MONTGOMERY COUNTY HISTORIC PRESERVATION COMMISSION
STAFF REPORT

Address:	113 Elm Ave., Takoma Park	Meeting Date:	7/23/2025
Resource:	Contributing Resource Takoma Park Historic District	Report Date:	7/16/2025
Project Contact:	Brian Rowland	Public Notice:	7/9/2025
Review:	HAWP	Tax Credit:	Partial
Case Number:	1116058	Staff:	Dan Bruechert
Proposal:	Door and Window Replacement

4 EXISTING SIDE (WEST) ELEVATION
A2 1/4" = 1'-0"

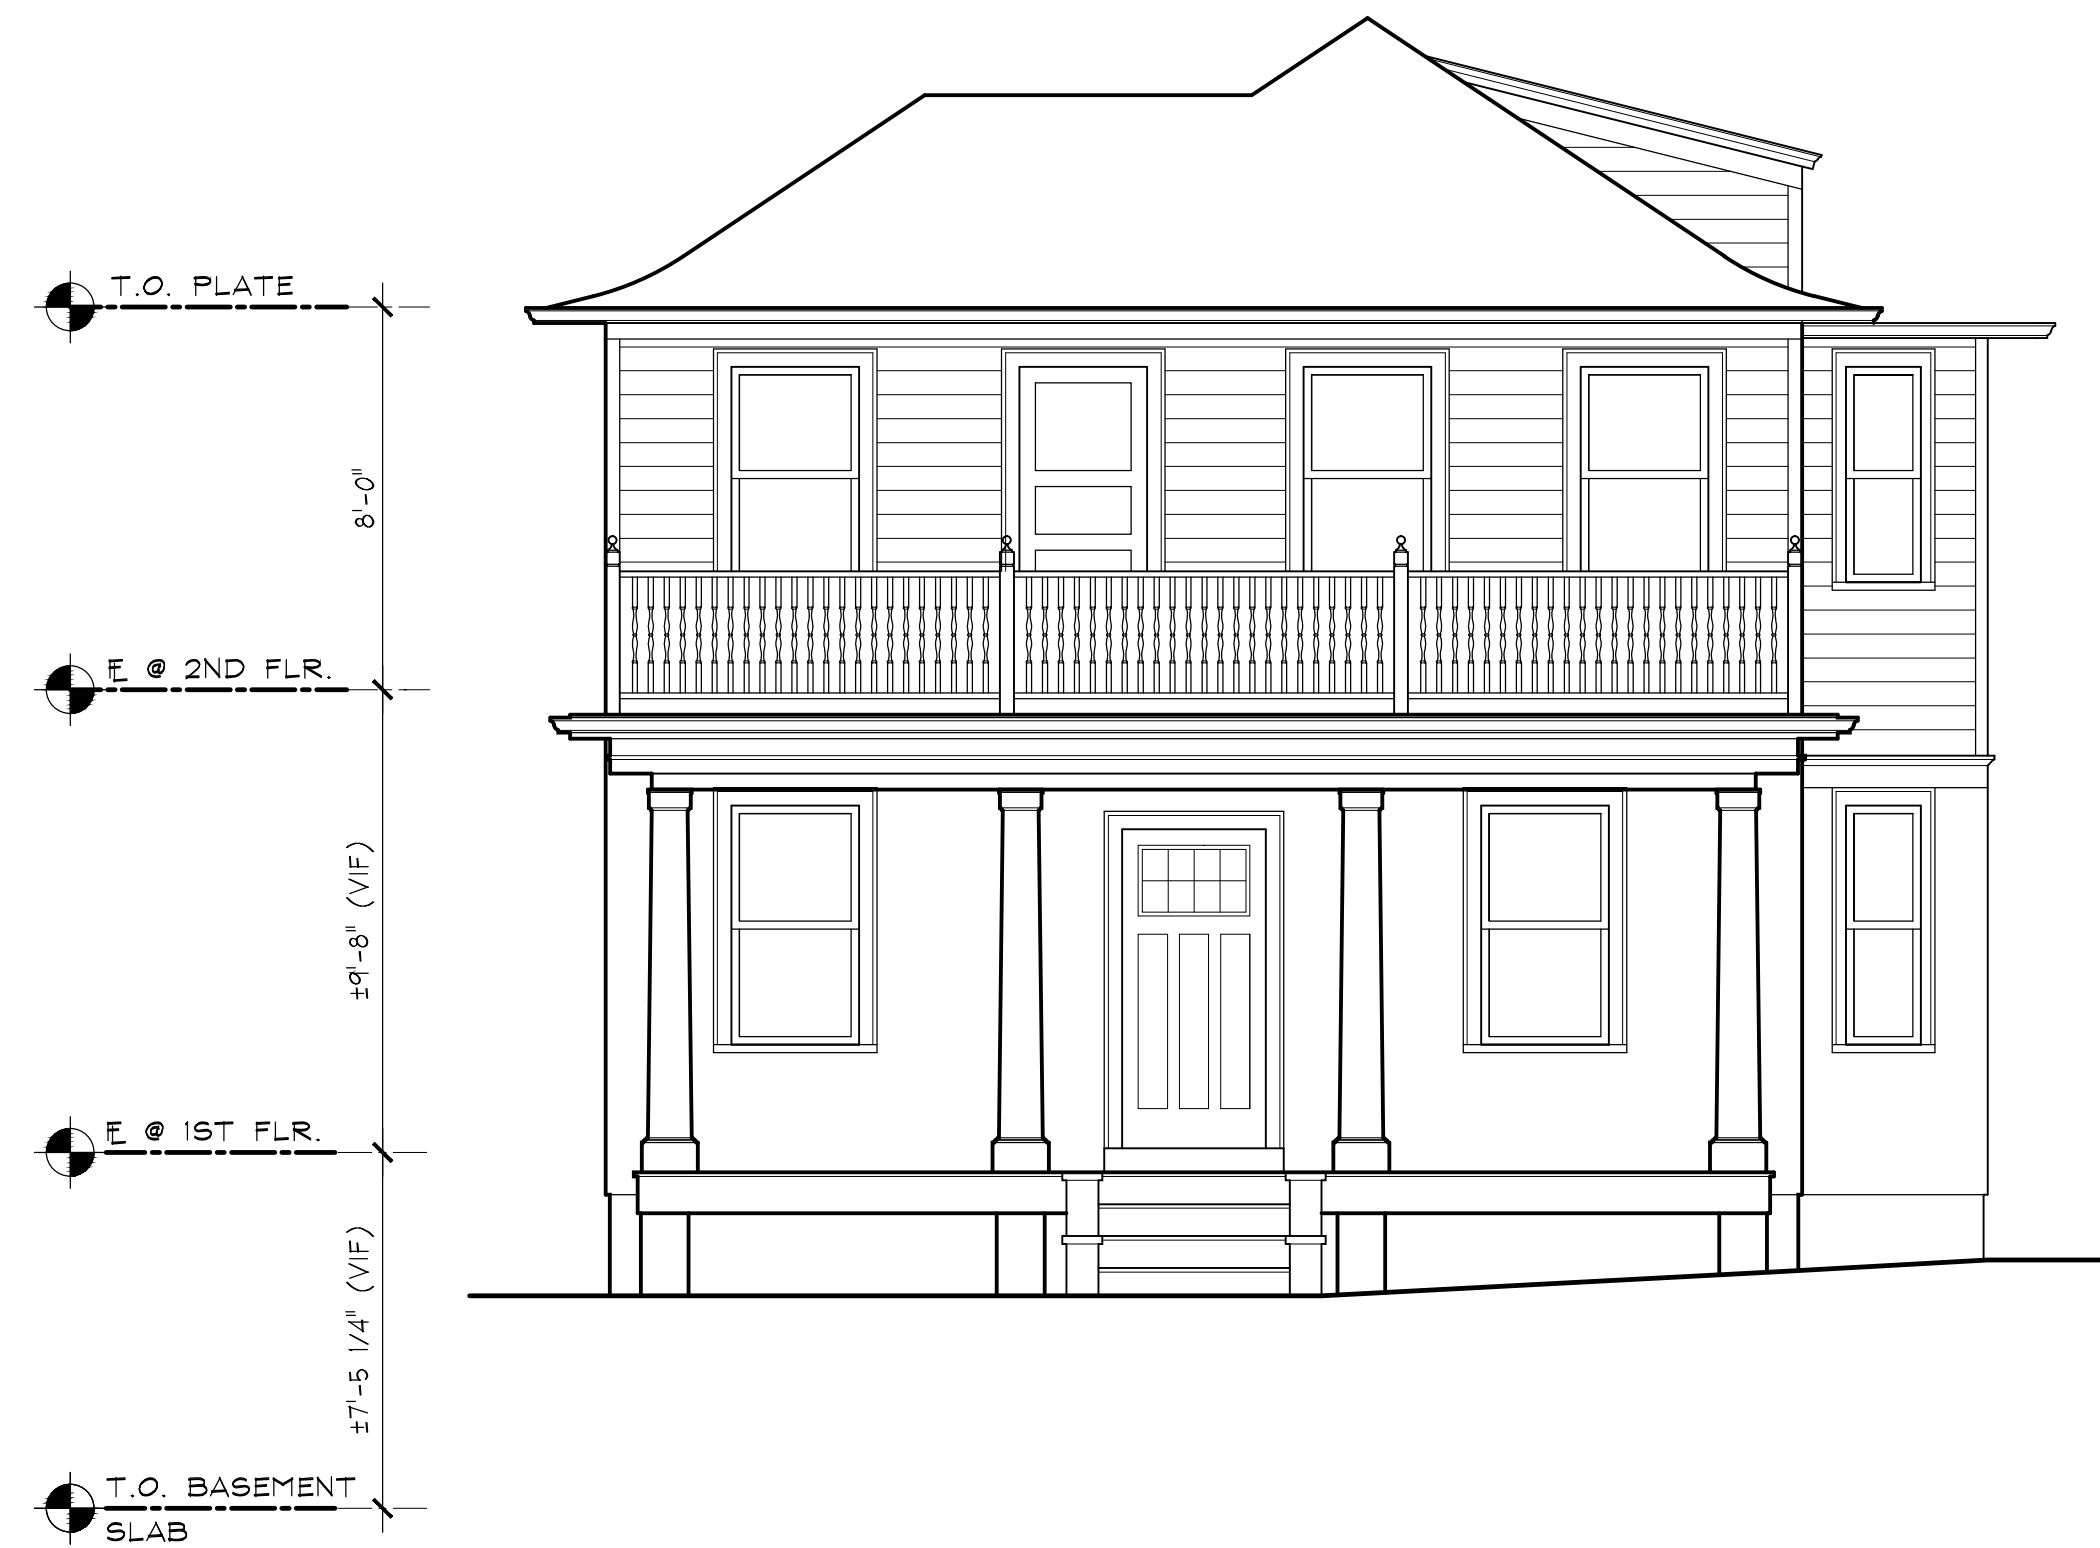
The applicant proposes to remove and replace a total of eight windows (see *Figure 3*, below). Seven of the proposed window removals are on the left side and one is on the rear. The windows on the right elevation are one-over-one wood sashes and Staff finds their appearance and condition are consistent with the house's 1913 date of construction. The window on the rear is a two-over-two sash window that appears to have been installed when the rear was expanded, between 1927 and 1959.

Based on the information included and the application and Staff's observations at a site visit, the windows show signs of paint failure, joint failure, surface mold, and rot within the frame. Due to these issues, the sashes are no longer weathertight. Surprisingly, the sash cords in several of the windows are still present.

In place of the existing windows, the applicant proposes to install Pella Lifestyle, aluminum-clad wood windows in matching size in one-over-one configurations and to replace the trim in matching dimensions. Staff finds the profiles and proportions of the proposed windows are compatible with the existing windows. The outstanding issue is the material. The HPC has consistently approved appropriately detailed clad wood windows for additions and new construction throughout the Takoma Park Historic District. However, evaluation of a substitute material on Contributing resources has been undertaken on a case-by-case basis. The primary considerations of the use of substitute materials include, design significance of the feature, visibility from the public right-of-way, and compatibility of the substitute material's appearance. Considering these criteria, Staff finds the proposed window is not appropriate.

First, Staff finds that historic wood windows are almost always considered character defining features. The size, profile, placement, and finish are all significant characteristics of wood windows. In addition to evaluating the proposal under the *Design Guidelines*, Staff looks to *Standard #6* for the recommended treatment for replacement windows. *Standard #6* states that when the severity of deterioration requires replacement of a distinctive feature (as Staff recommends, above), the new feature will match the old in design, color, texture, and where possible materials. Staff finds these criteria can be satisfied with a one-over-one wood window. While Staff does not take a position on the appropriateness of any specific color for the subject property, it does find that a wood window would successfully replicate the texture and materials.

Second, Staff finds that seven of the eight windows are visible from the public right-of-way along the right side. *Figure 4*, below shows the highly visible right elevation. A 10' (ten foot) wide dedicated alley between the houses at 113 Elm Ave. and 111 Elm Ave. will preserve the open space between the properties and maintain the open appearance of the left elevation.

Third, Staff finds that while the finish quality of aluminum clad wood windows is coming closer to a painted wood window, it still does not match the appearance. Most factory finished aluminum clad wood windows are shinier than a painted wood window and do not develop a patina like a wood window will.

For these reasons, Staff finds that wood is the only appropriate material for the proposed seven windows on the right elevation.

Having reached this conclusion, instead of denying the window replacement, Staff recommends the HPC conditionally approve the seven one-over-one wood windows that are appropriately sized to fill the historic opening, with final approval authority delegated to Staff. This will allow the applicants to continue to move the project forward without having to wait for a future HPC meeting, when the commission has already determined the appropriate requirements for this feature. If the applicants have additional questions about an appropriate window, Staff can direct the applicant to several window manufacturers who produce wood windows that have been installed in the Takoma Park Historic District.

Staff finds the proposal to replace the rear window with an aluminum clad window is appropriate primarily because the *Design Guidelines* apply a much more lenient standard to elements that are not visible from the right-of-way; and because this window opening is part of a later addition to the house. An aluminum clad window in this window opening would not qualify for the tax credit.

1. Replacement windows on the right elevation must be wood, one-over-one sash windows. Detailed specifications must be submitted to Staff prior to installation.
2. The replacement door must be a wood half-light door. Detailed specifications must be submitted to Staff prior to installation;
